Oil Injection Pump Sport Jet

Models Affected

1995 SPORT JET 90 & 120
S/N 0E125390 - 0E141088

1996 SPORT JET 95XR & 120XR
S/N 0E141089 - 0E200011

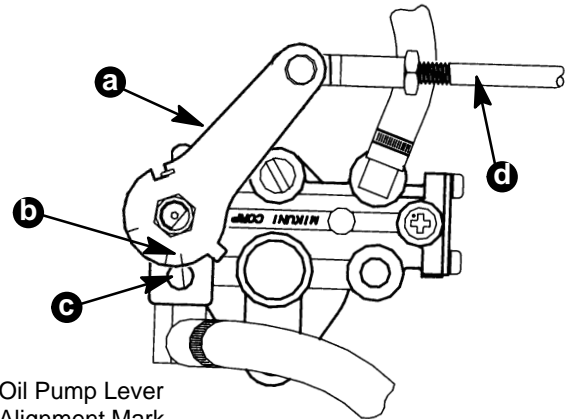
There have been sporadic reports of Sport Jet powerheads scoring pistons during the break-in period. Engineering had found that the oil injection pump has not been consistently adjusted to provide the correct ratio of oil at wide open throttle. Several engines were found where the oil injection pump was metering oil at 70:1 rather than 50:1.

This was caused by a change where the fixed wide open throttle stop was replaced by an adjustable stop. The adjustable stop was necessary to increase the idle timing to achieve the 1000 rpm idle speed with a closed throttle shutter. The closed throttle shutter is a requirement for the Turn Key Start feature.

To correct this potential problem, the procedure for adjusting the oil injection pump has been changed. The oil injection pump is now adjusted at wide open throttle position rather than at idle.

IMPORTANT: The oil pump adjustment must be made after all timing and synchronization operations have been performed.

1. Move towershaft to the Wide Open Throttle position. Inspect oil injection pump alignment mark (c) with the oil pump lever mark (b). This check may require the use of a small mirror.

- a - Oil Pump Lever
- b - Alignment Mark
(At Wide Open Throttle)
- c - Pump Alignment Mark
- d - Link Rod

2. Adjust oil pump link rod (d) to align the marks as necessary.
